This is to certify that Hega Realty Trust/KDA Development
has permission to renovate floors 2-5 add 6th floor
AT 545 Congress St Call 037 C017001

I have commenced the review of the building plans and require the following or have the following questions:

This letter is in response to questions and comments related to the structural system contained in Mike Nugent's memorandum dated 5/23/2005.

Re: Response to your comments of 5/23/2005 on Winslow Lofts

A1

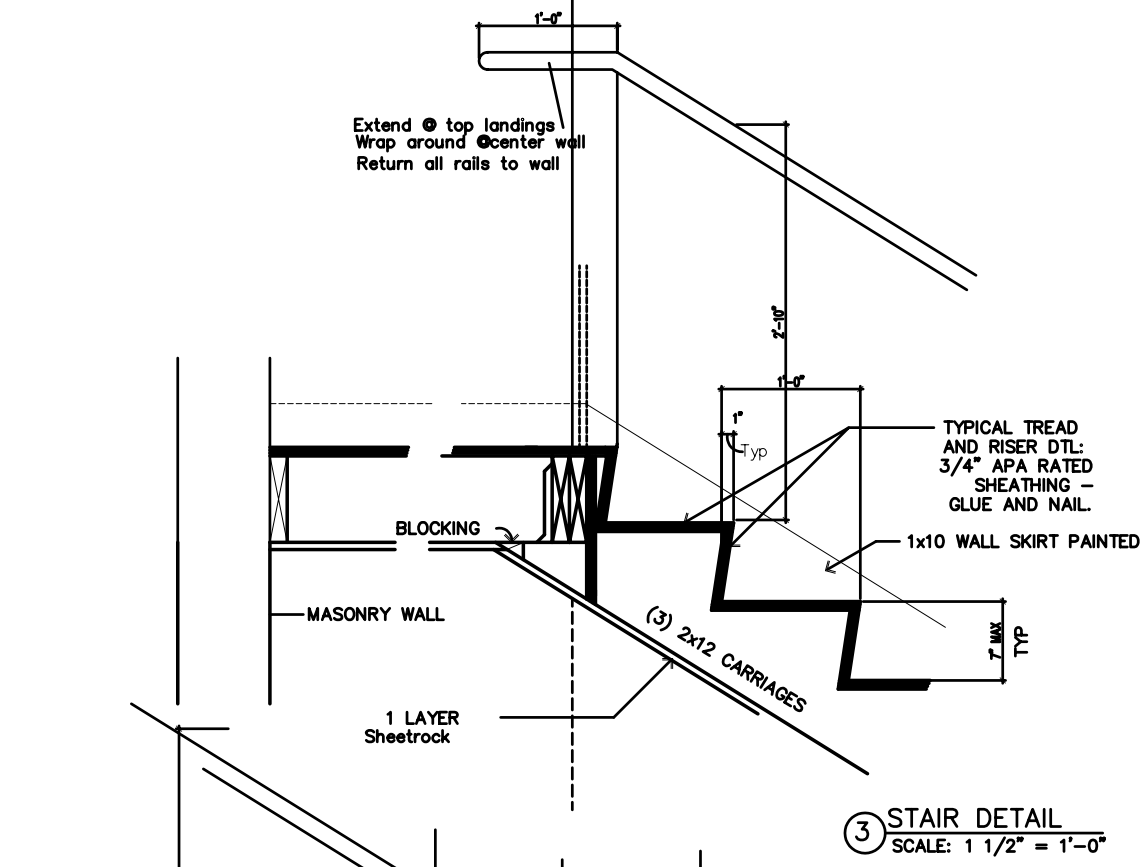
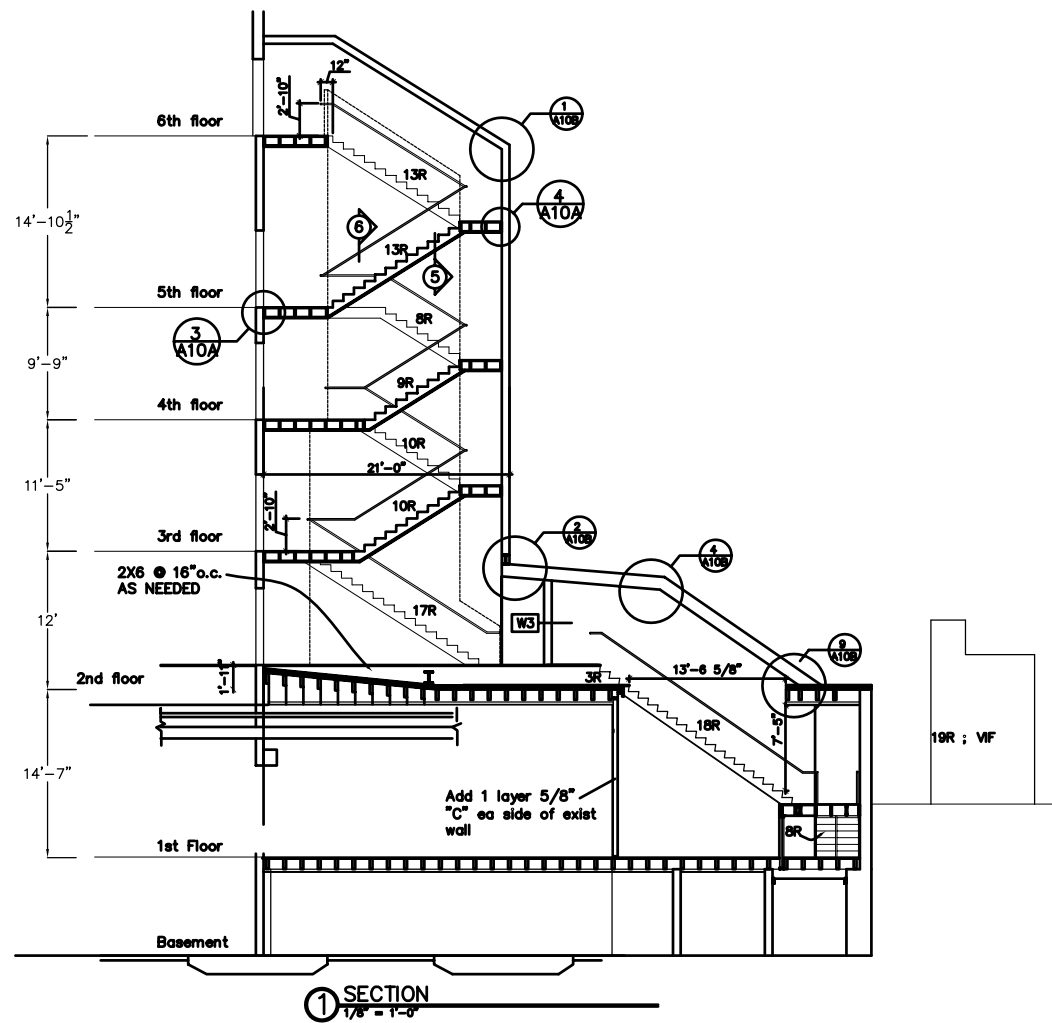
- 8) No handrails are shown on the "rear stairway" on A1 and A2. (and other floor plans) Does the Typical on AIO.A provide us with the assurance that all stairways will have code compliant handrails?

8. We no longer show handrails on our stairs but rely on the typical details. We have added an additional note to ensure we will have handrails on both sides of all stairs.

A10A

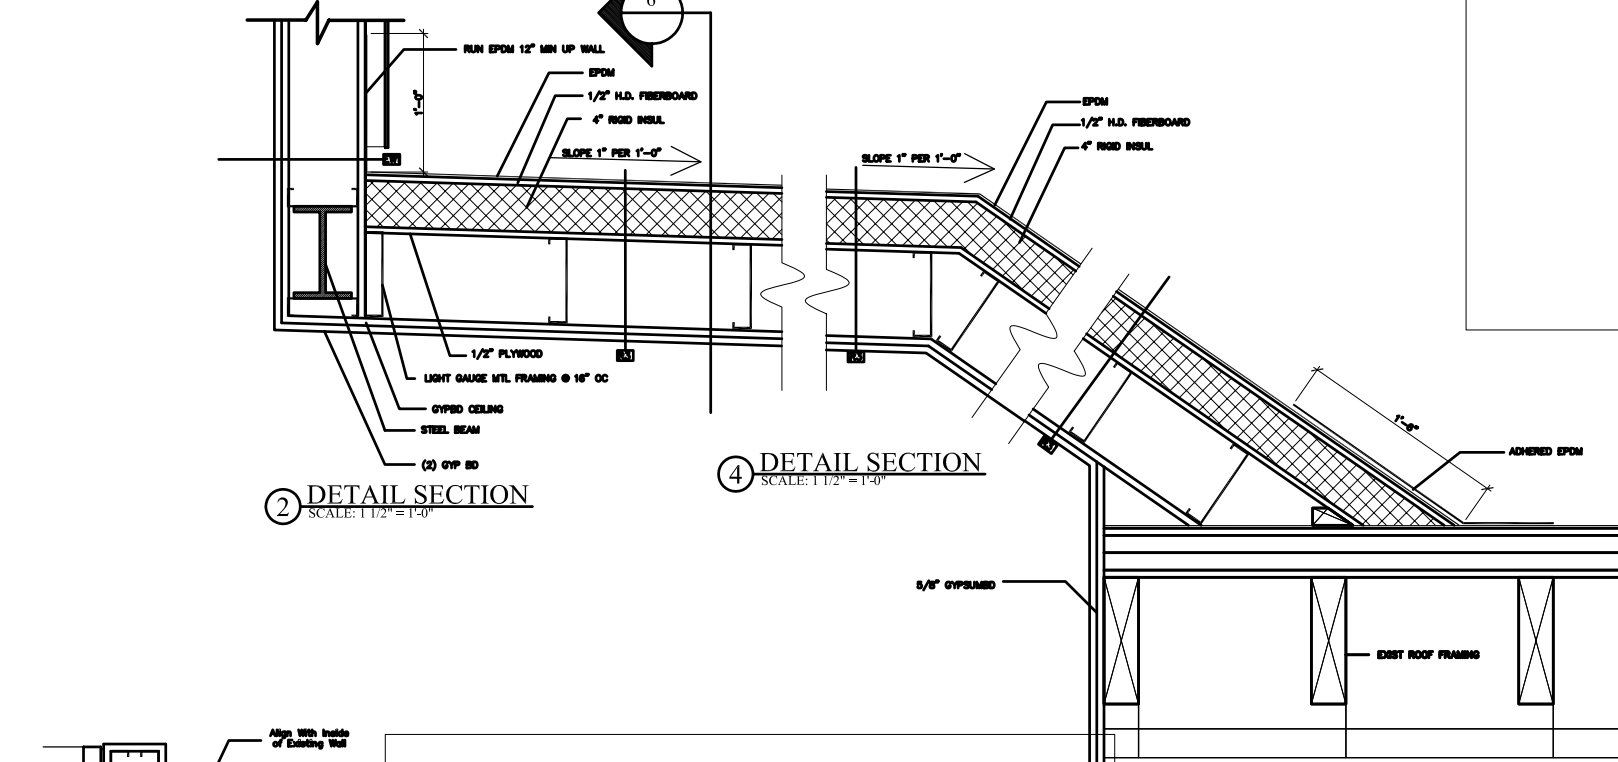
- 3) A.I.O.A figure 1. Please make sure that the first stairway does not exceed 12 feet from landing to landing.
- 4) Need the Sound transmission classifications for the Floor Ceiling and Party wall assemblies and well as the assemblies that separated the D/U's from the common areas.

1. Attached is a revision to our door specification referencing UL 100
2. The fire pole is a request of the owner, not within the code.
3. The distance in the first to second floor of the 2nd floor stairway is 11'-11 3/8" by calculation. We have added a note on sheet A10A that no construction commence until this dimension is verified.

OWNER:		ARCHETYPE, P.A. ARCHITECTS 48 Union Wharf Portland, Maine 04101 (207) 772-6022 Fax (207) 772-4056	
Project:		WINSLOW LOFTS CONGRESS STREET PORTLAND, MAINE	
Date	Scale	Revisions:	
APRIL 22, 2005	1/4" = 1'-0"		
3RD, 4TH & 5TH FLOOR FRAMING PLAN			
S4

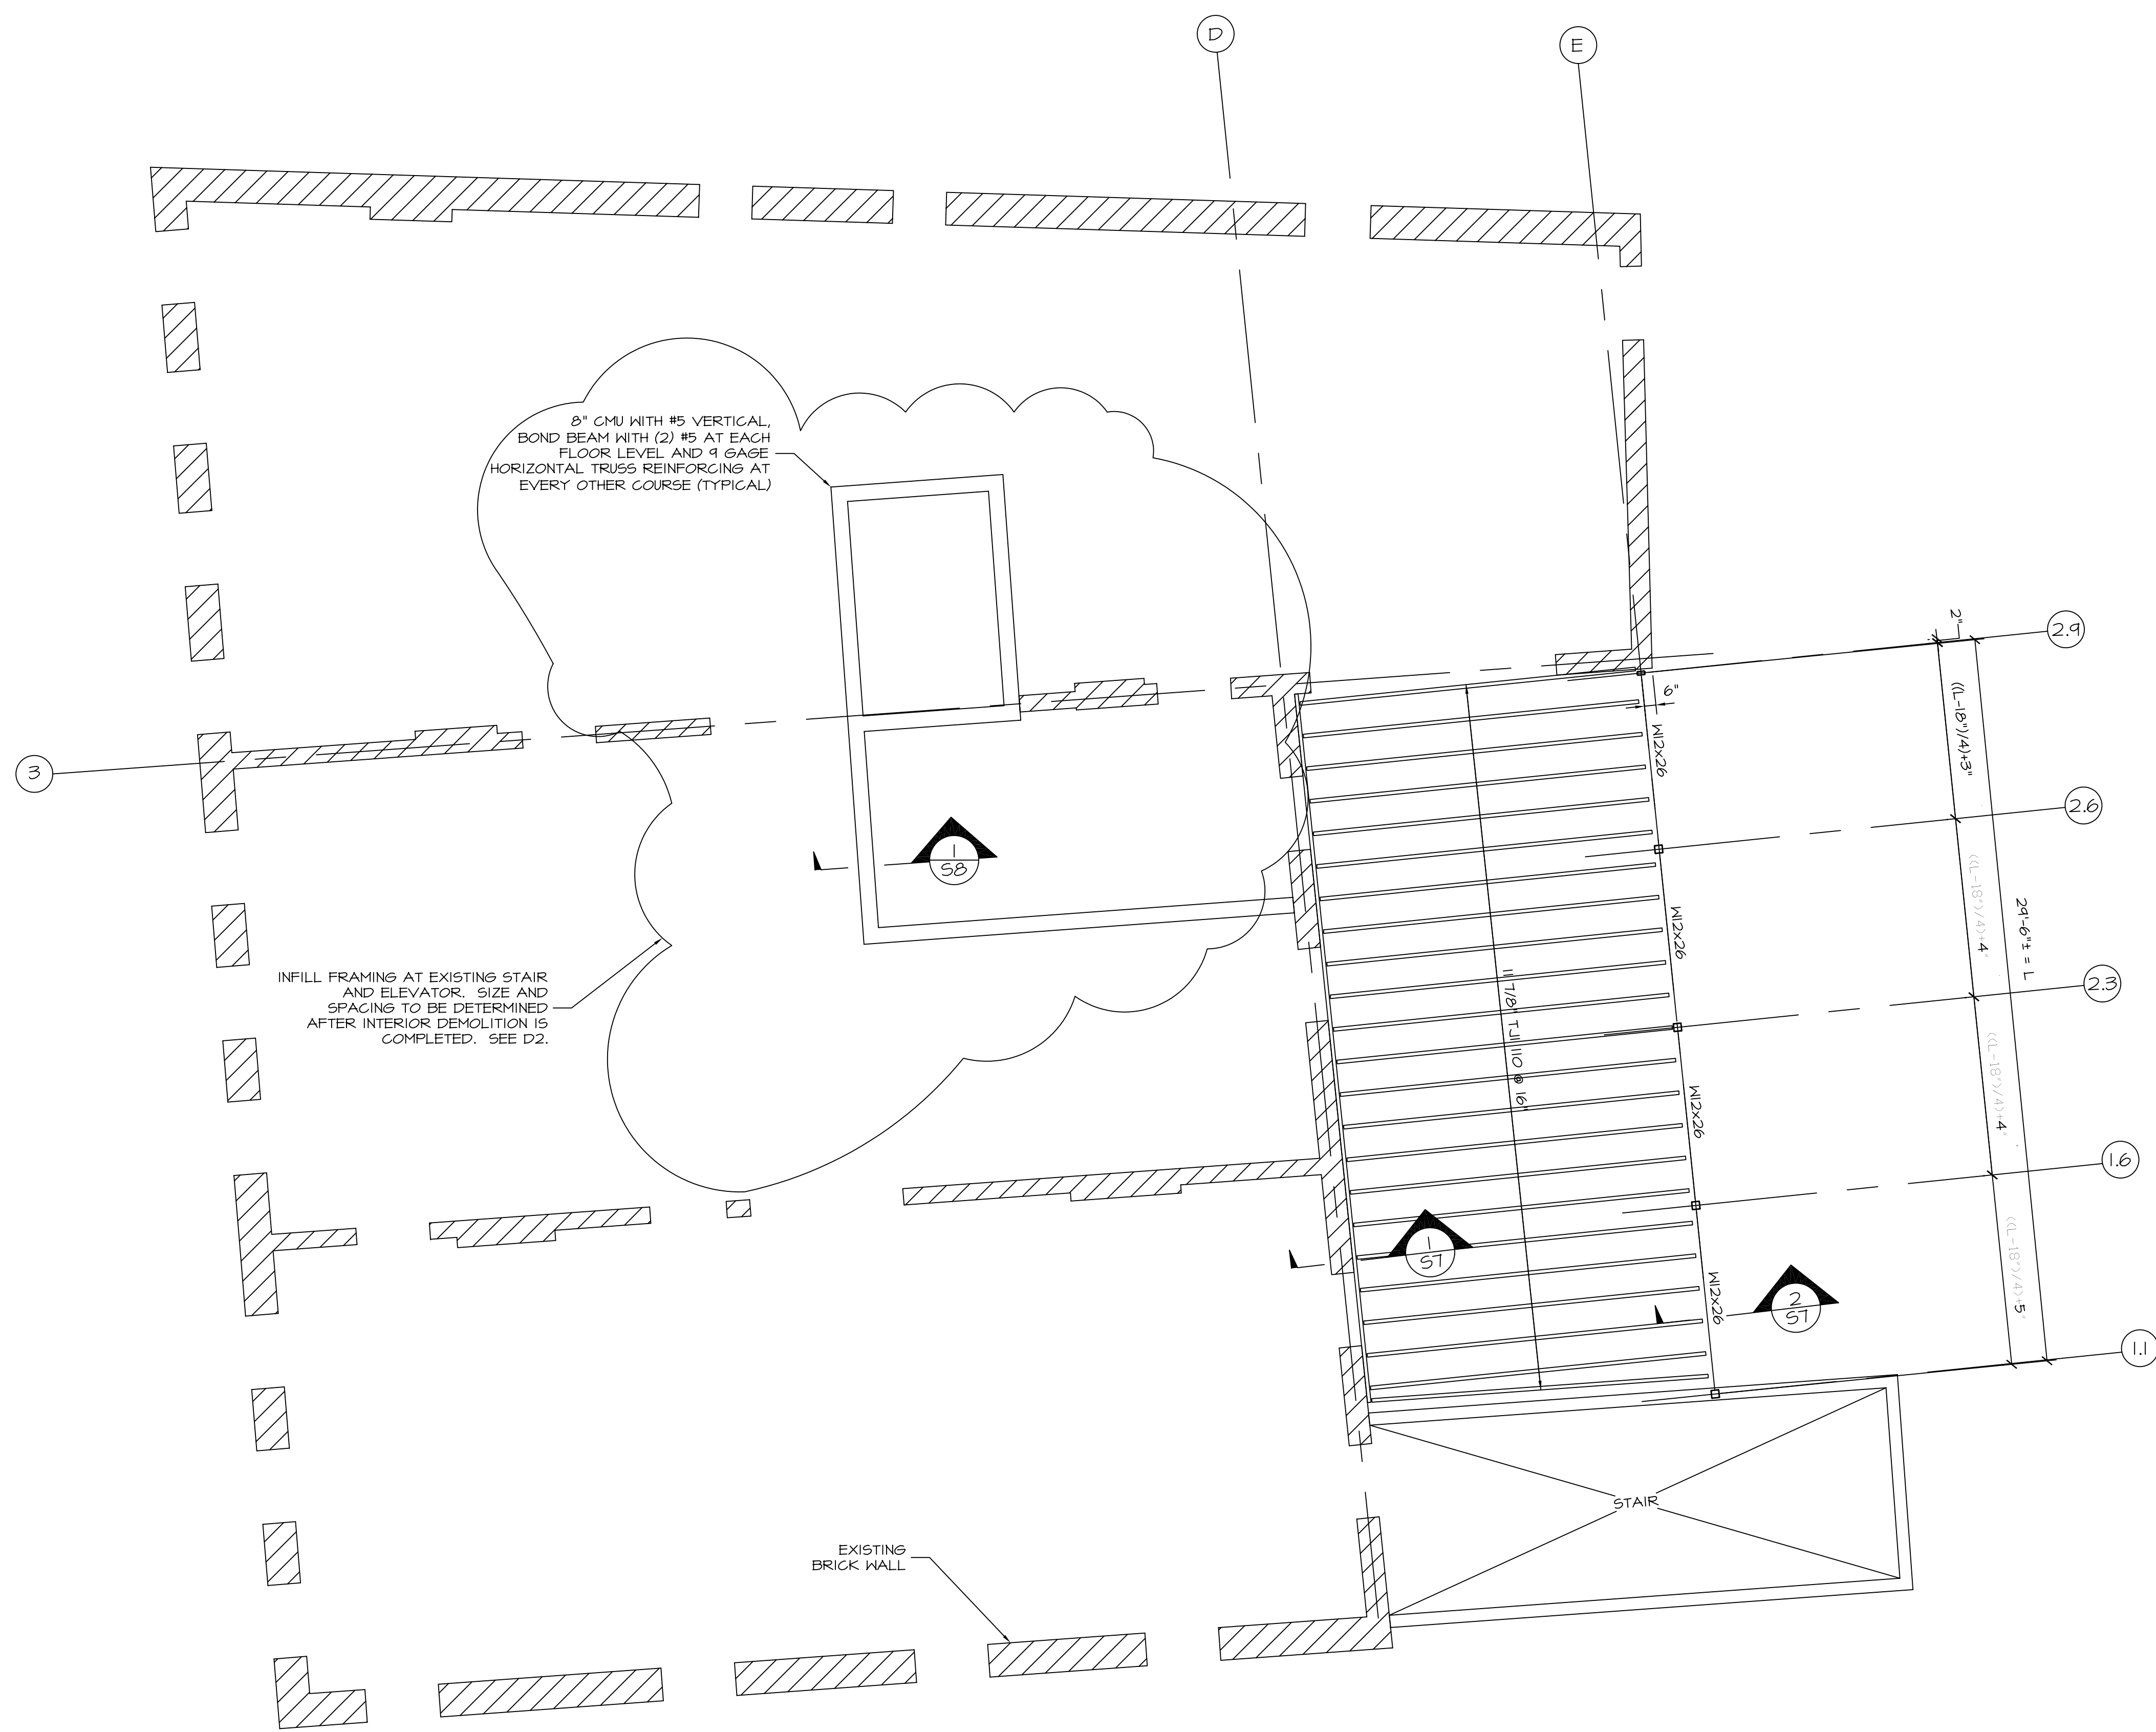
- 9) Need structurals for exterior porches/balconies with Guard Rail Details.
- 10) Although implied, by the fact that Dave T. stamped the plans, I'm looking for specific commentary that the existing building has been evaluated and will carry the new loads imposed by the vertical expansion.

- 9. **The basic** framing for balconies is shown on sheet **S4**, revision **1** dated 05/06/05. Handrails are shown **on** sheet A12. I **will** confirm the structural capacity and code conformance of handrails and issue sketches **as** required.
